SAM G55 Series Family Silicon Errata and Data Sheet Clarification

Data Sheet Clarifications

The following typographic corrections and clarifications are to be noted for the latest revision of the device data sheet (Atmel-11289F-ATARM-SAM-G55G-SAM-G55J-Datasheet_27-May-16).

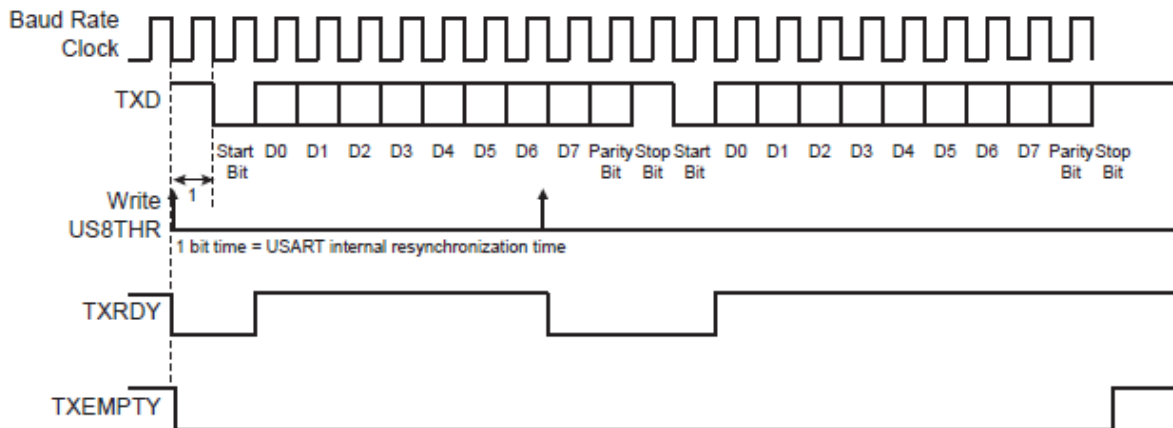
Figure 30-6 is incorrect. The corrected figure is as shown below:
